# SEAT LEON CUP RACER 2016

## TECHNICAL NOTE 10/2016

### Fuel tank connectors cover

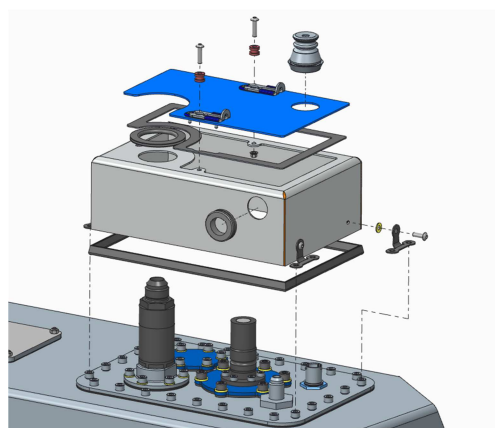
The fuel connections on the cockpit bay **must be protected** in all cars with FT3 fuel tank. This safety feature has been already introduced on the spare parts catalogue as well as on the SEAT Leon Cup Racer technical forms.

All necessary parts to adapt the existing cars with FT3 fuel tank are included on the kit reference: **5F6201027**

### Fuel line protection

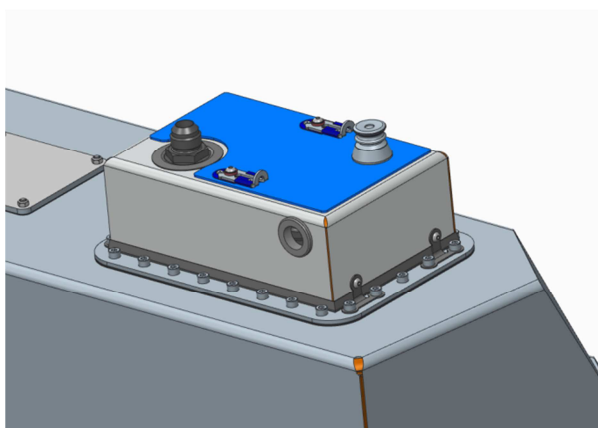
The fuel line from the fuel tank to the engine bay has to be covered with a fire coating protection. You have two options to update it:

By adding a coating protection over the existing D6 pipe:

By replacing the D6 pipe for a new one already coated
